### Say No to Plasrefine

Response to

Wingecarribee Shire Council's

GHD's Response to Submissions.

Table 1. Recommended riparian corridor widths

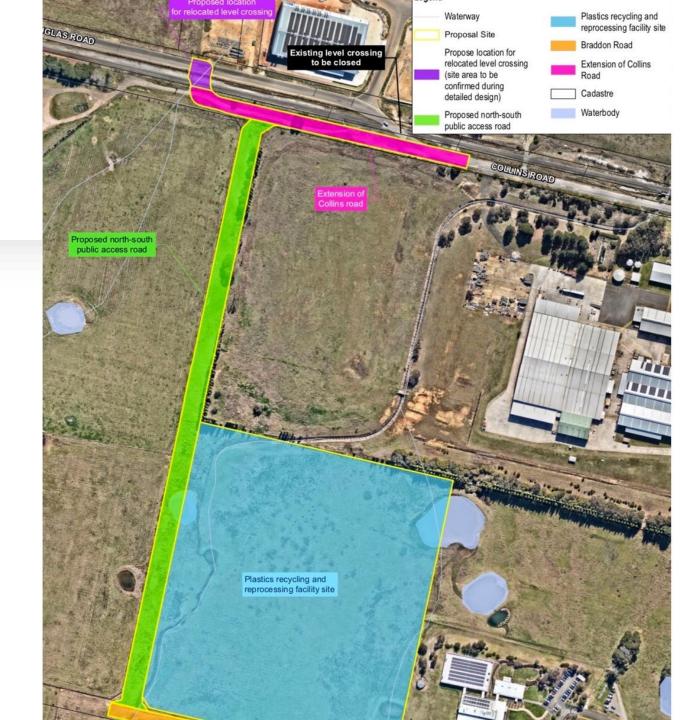
There is no ability to connect an equivalent area to the Riparian Corridor to offset a road in the Riparian Zone within the scope of this proposal on this site.

Council's placement of the road corridor predates the 2012 DPIE Changes to controlled activities in Riparian Zones.
